ADDENDUM NO. 03.1

SUBJECT: Addendum No. 03.1 – Public Safety Complex Construction

Project: 19018_COK Public Safety Complex
Date: 24 February 2021

Addendum 03.1 forms a part of Construction Documents and modifies the original drawings and specifications issued on February 1, 2021.

S110.3

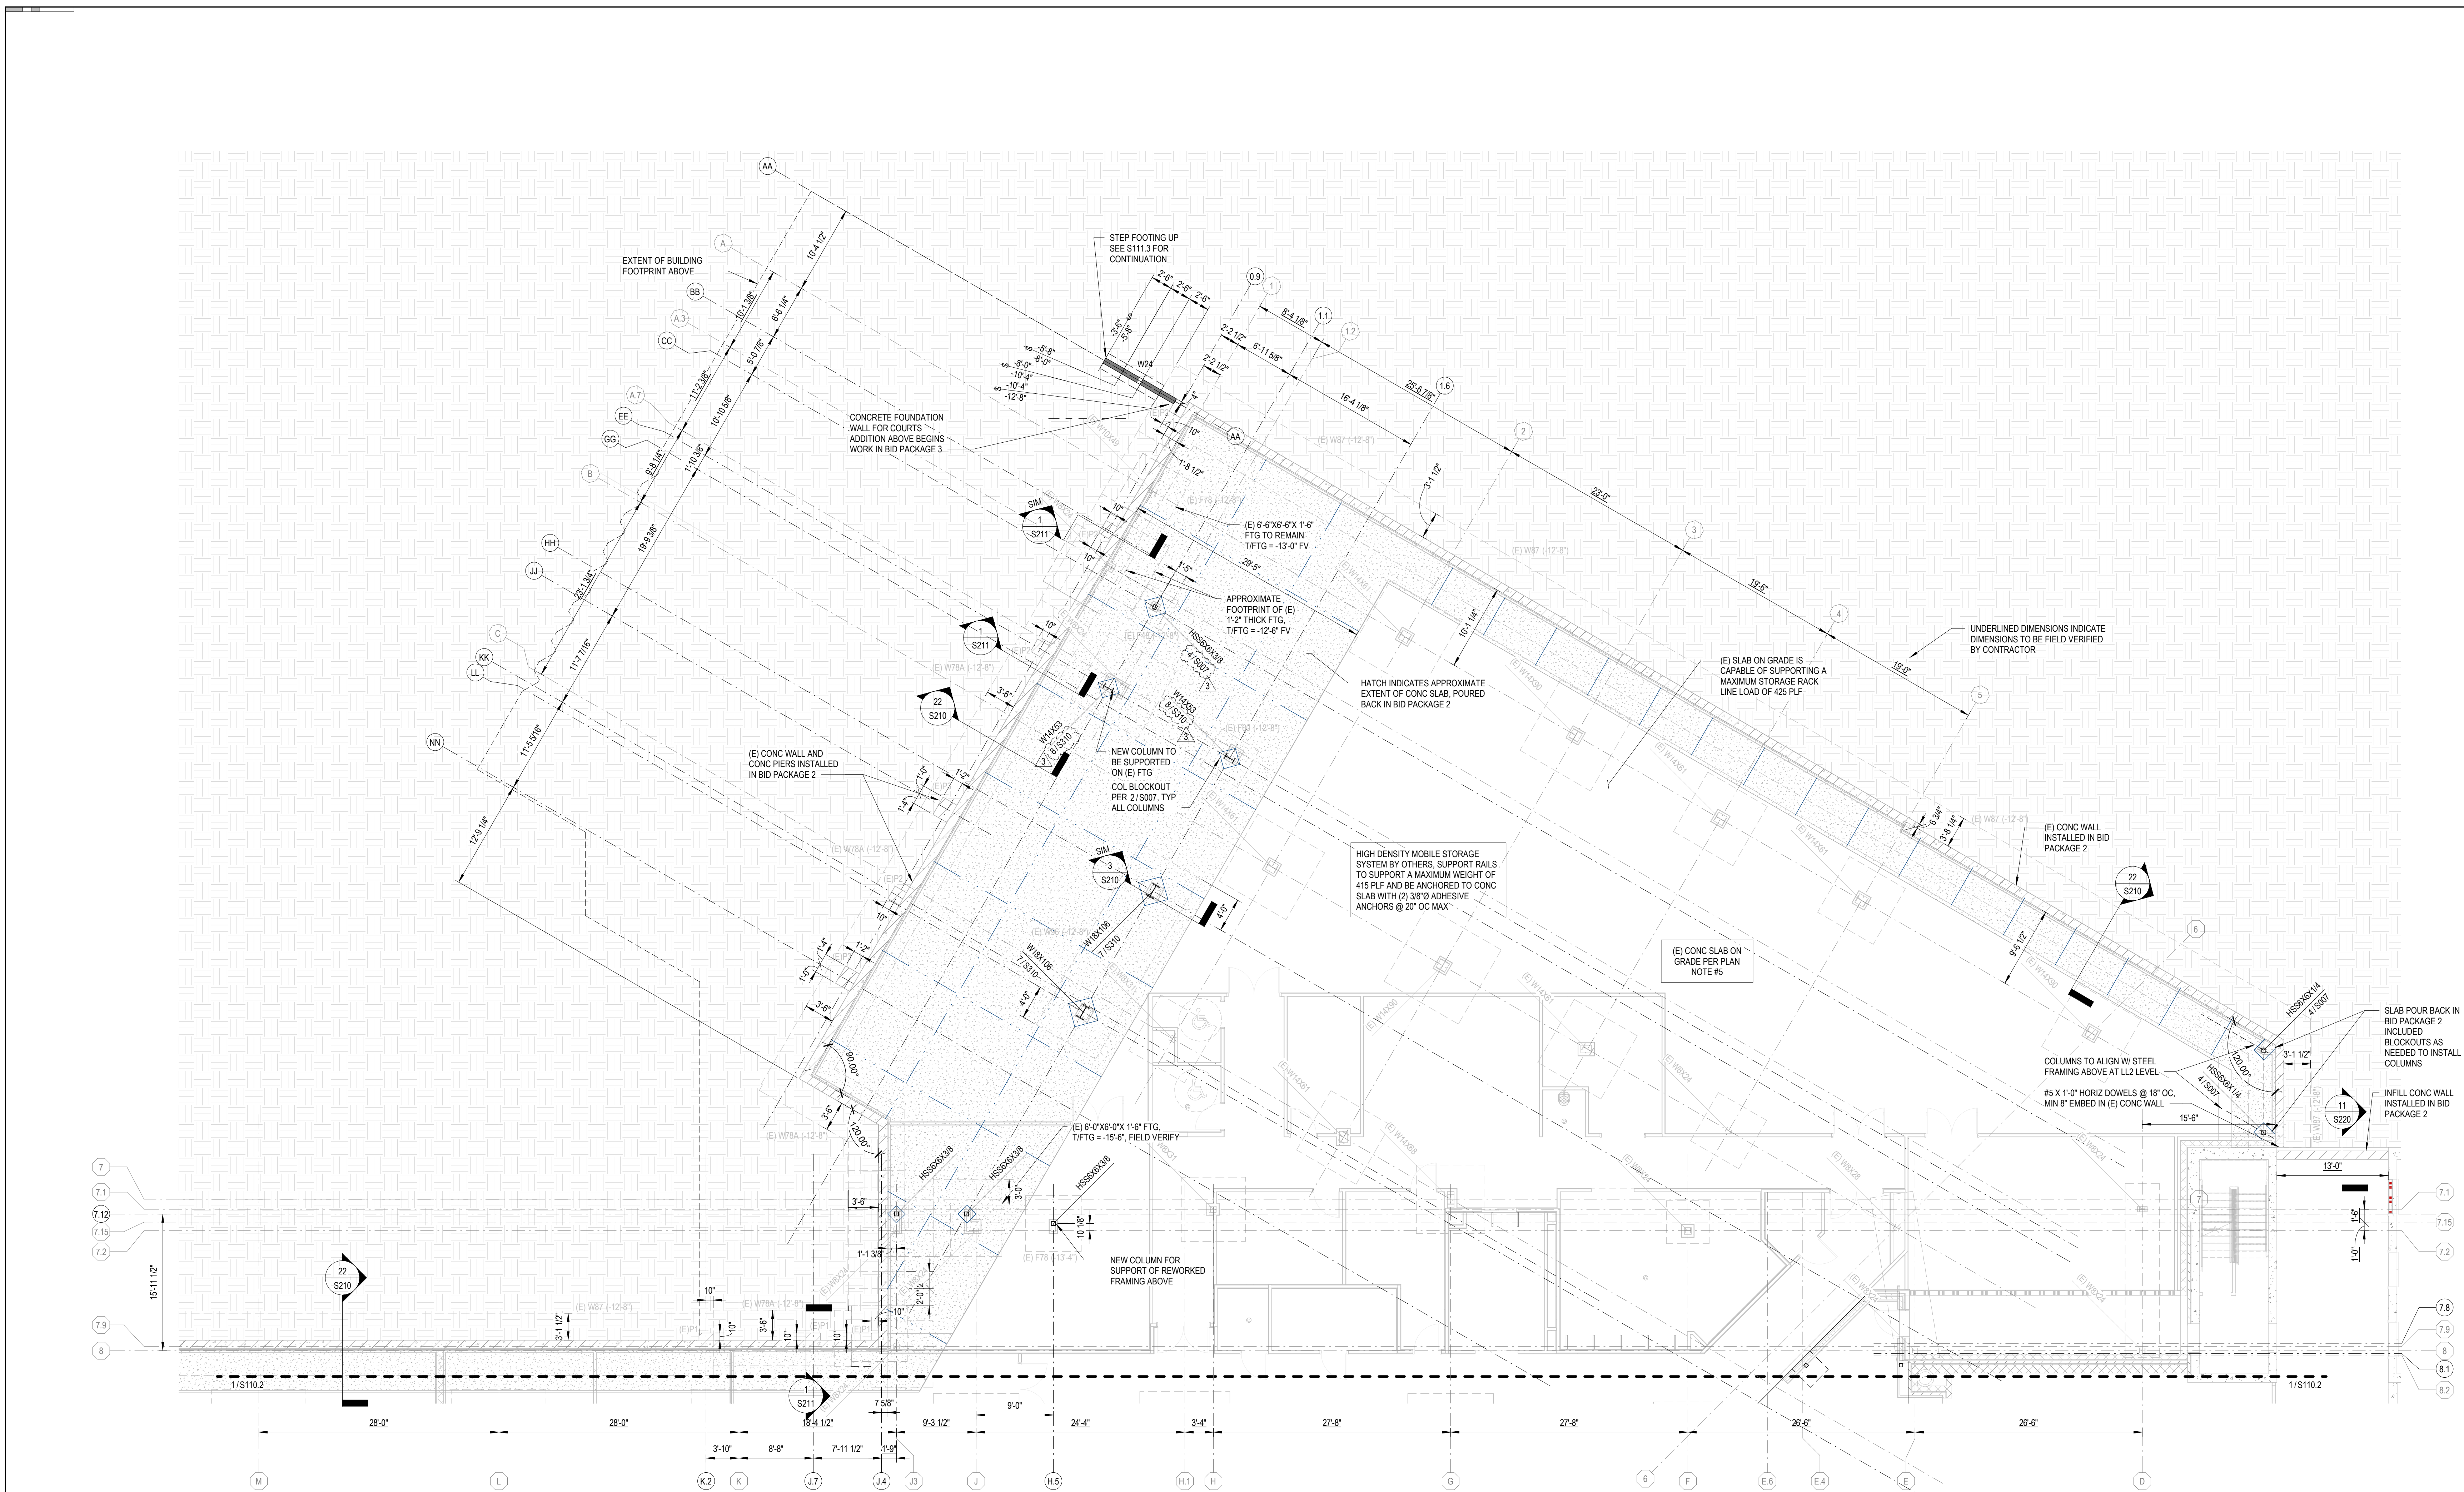
73. Drawing S110.3 does seem to indicate that the Pour Back Slab was indeed performed in BP2. Blockouts for 2 new columns new CL6 and CL7 are indicated as existing. Are blockouts in place for all the other columns at CL1 - CL1.6 or will the pour back slab need to be saw-cut and removed?

- a. **Blockouts will be in place for all columns within the pour back area that is being poured in BP2.**
74. Drawing S110.2 CA LL3 B. Steel members are shown at the Existing Elevator Pits. Is this new steel in this Bid Package? If so, please provide connection details, etc.

S114.2

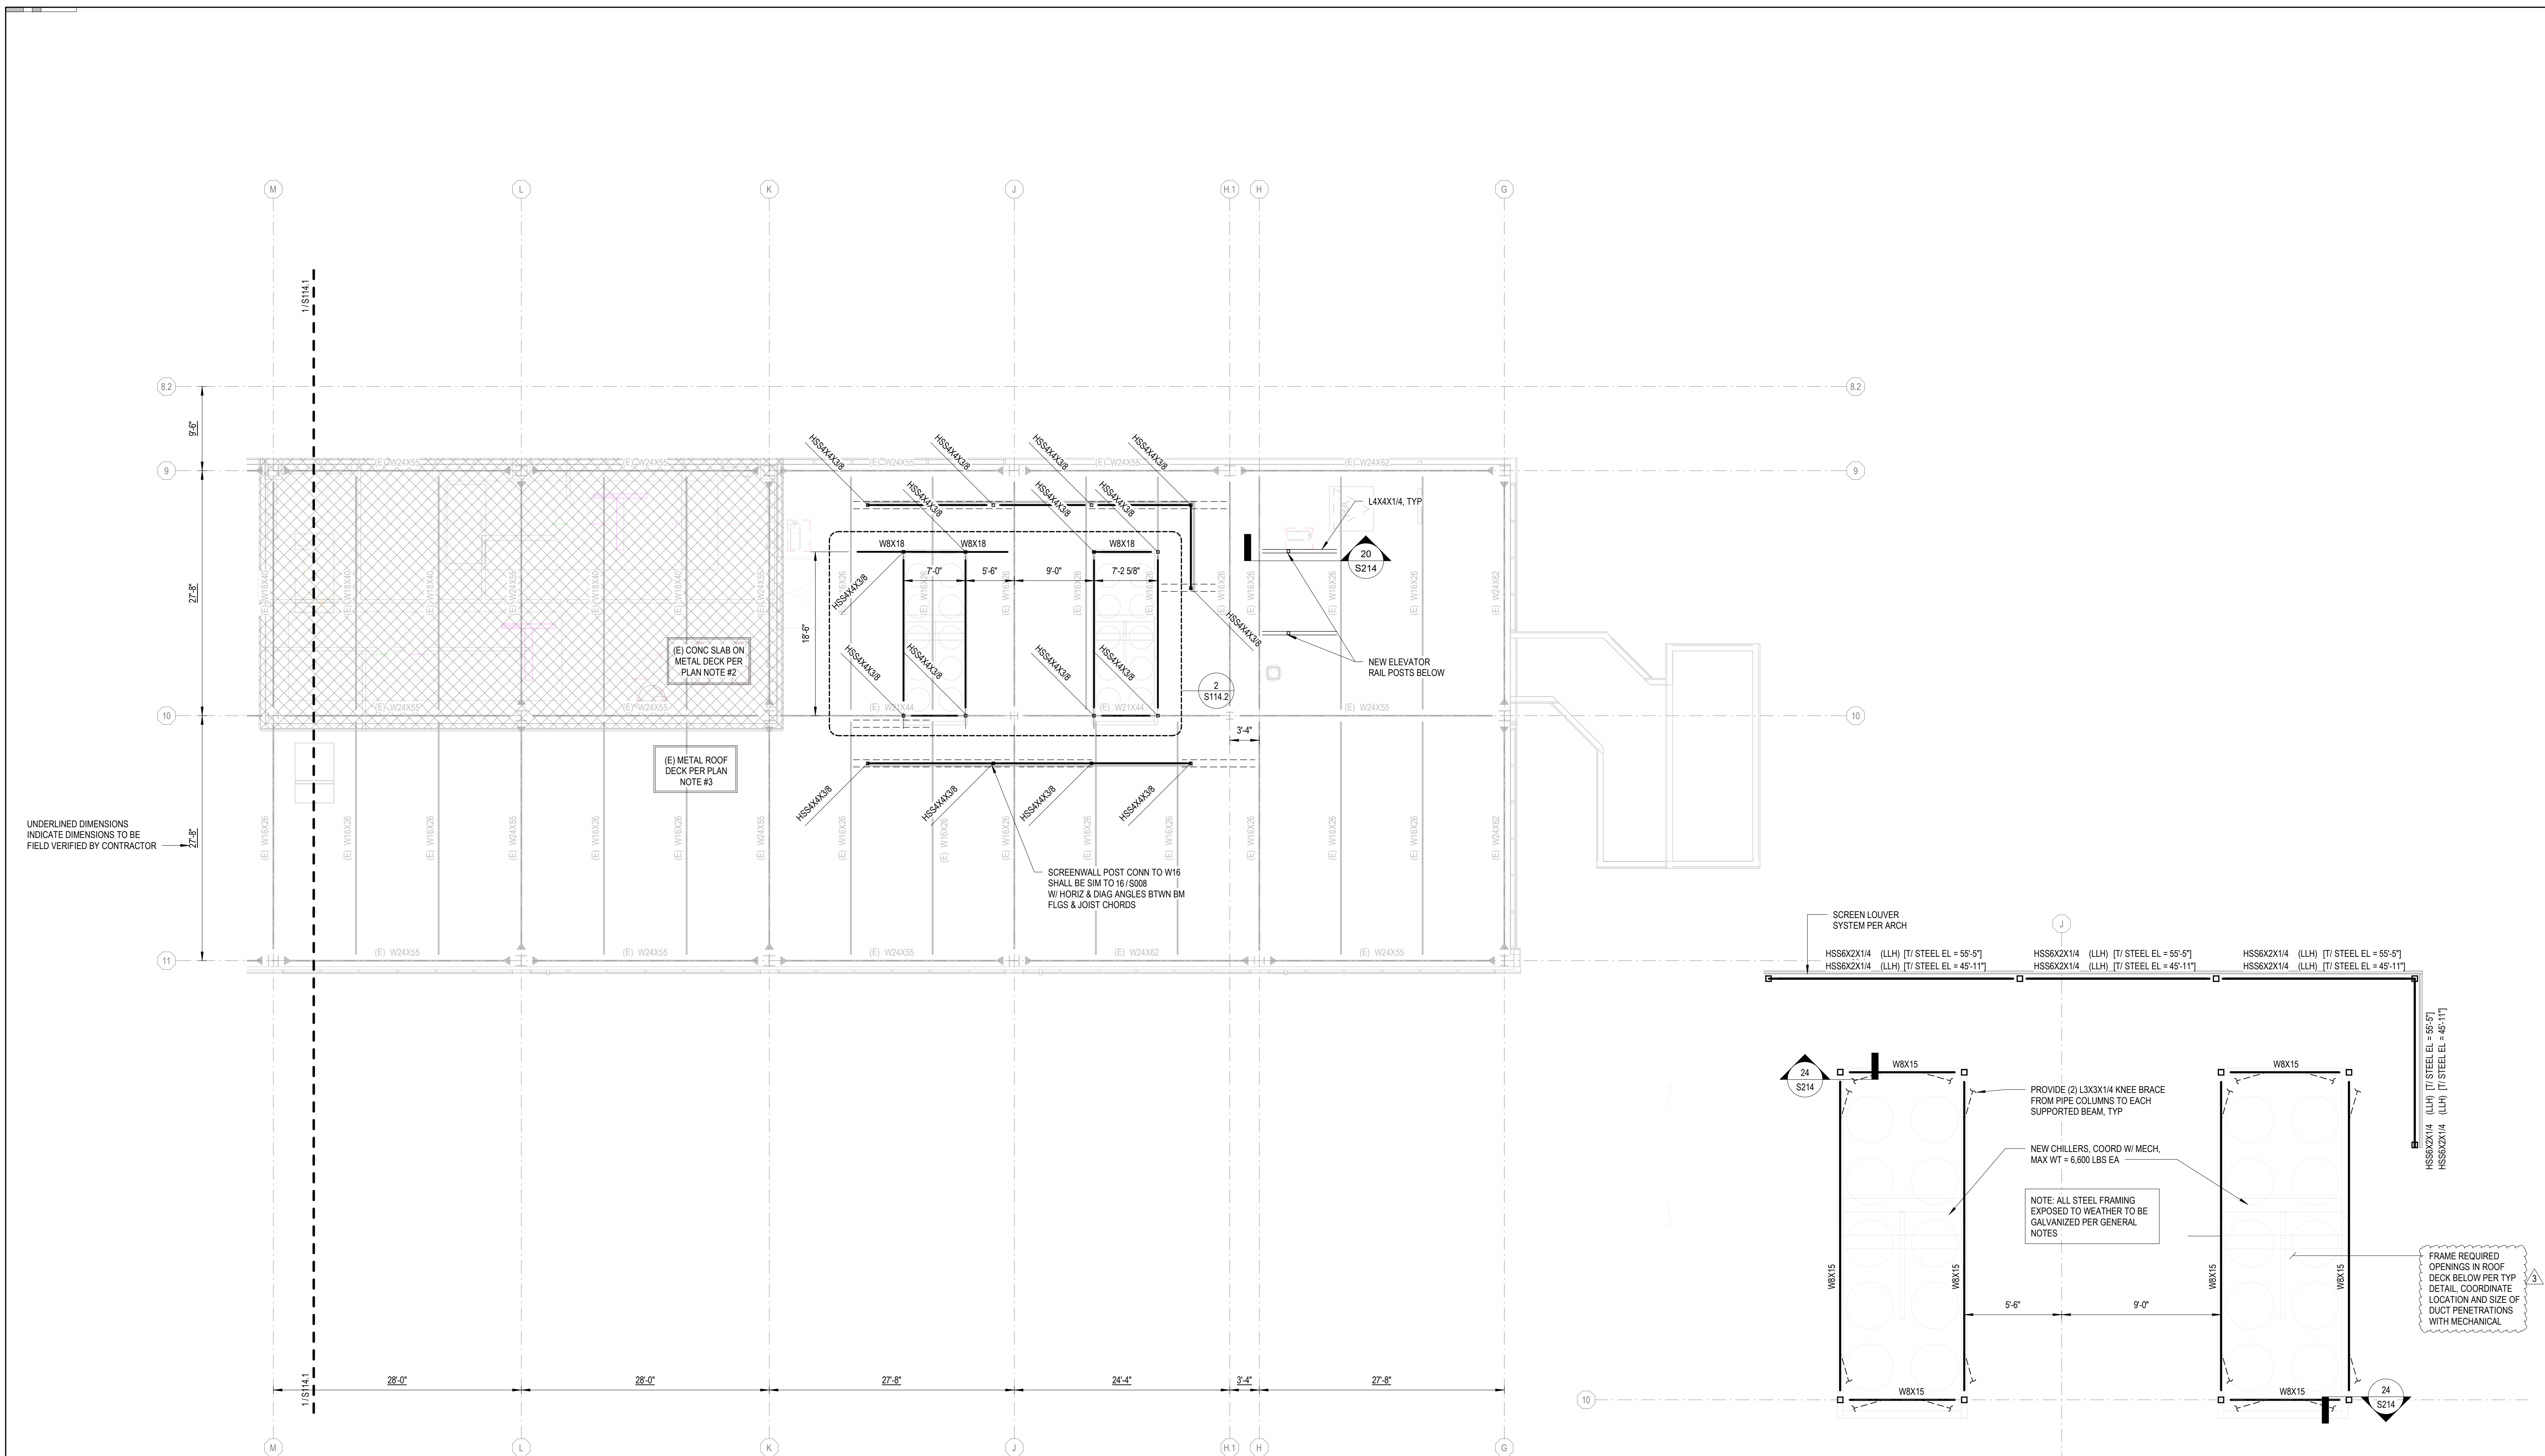
77. 2/S114.2 Chiller Support Frame. Note says "Frame required openings in roof deck below". Please provide size and quantity of such.
- a. **Required roof deck openings for duct penetrations should be coordinated with MEP drawings.**

FP101

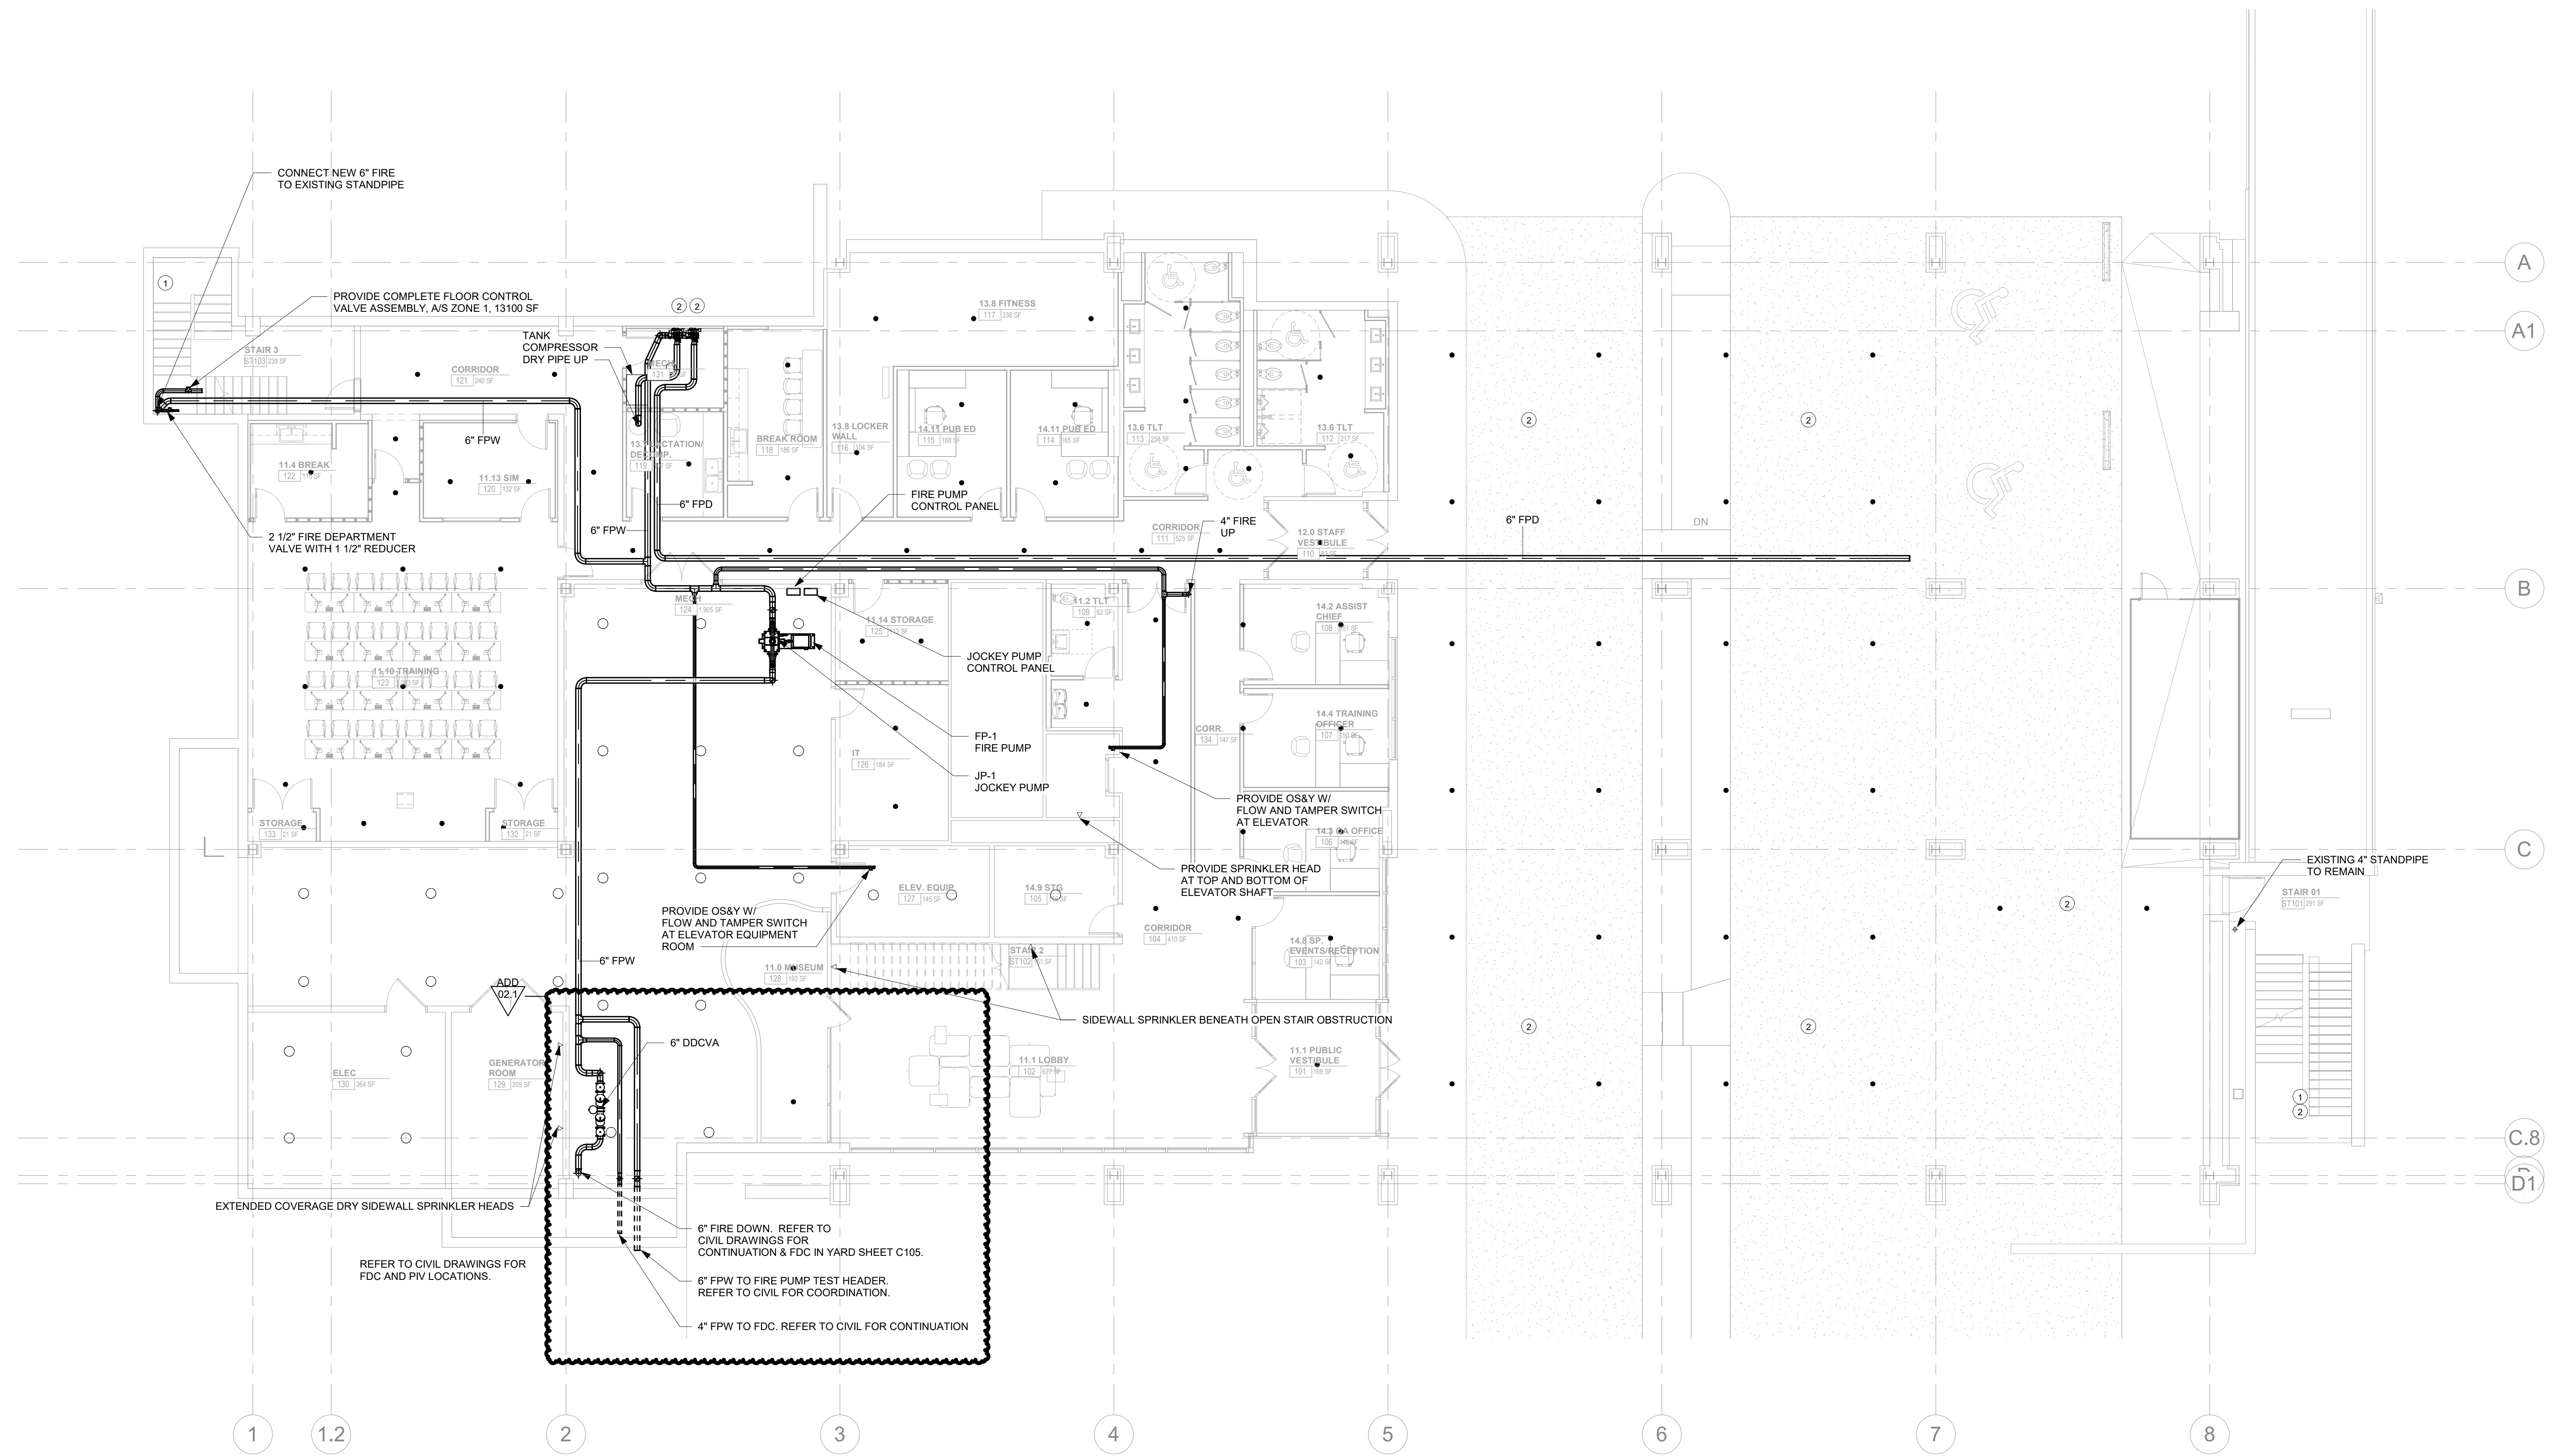
- **All sprinkler heads will be new. Notes will be updated.**
- Sheet FP101 show using the existing run-ins for the Women's Pavilion. During our site visit we noticed the run-in is in a different location and it has been cut off even with the wall leaving nothing to connect with. This also appears to be the same for the remote F.D.C. Please advise on how to connect?
